## MODIFICATION OF THE PLASTIC BUCKETS JET AND EUROJET

As part of the continuous improvement of the quality of our products, we decided to modify our plastic buckets at the attachment area.

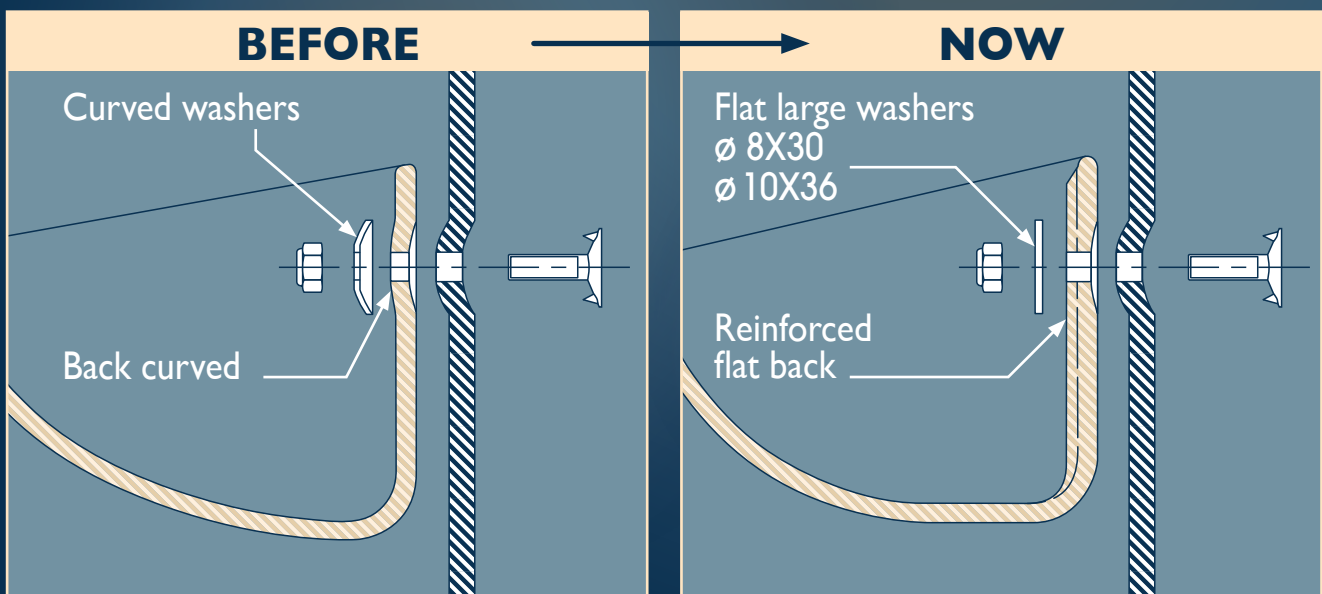
This means now, the use of **FLAT WASHERS** with the buckets **JET** and **EUROJET** in **HDPE, PA** and **PU** manufactured by **STIF**.

Following this modification, the attachment area of plastic buckets strengthened and efforts are better distributed on the back of the bucket. Flat Washers to use now are 8x30 and 10x36.
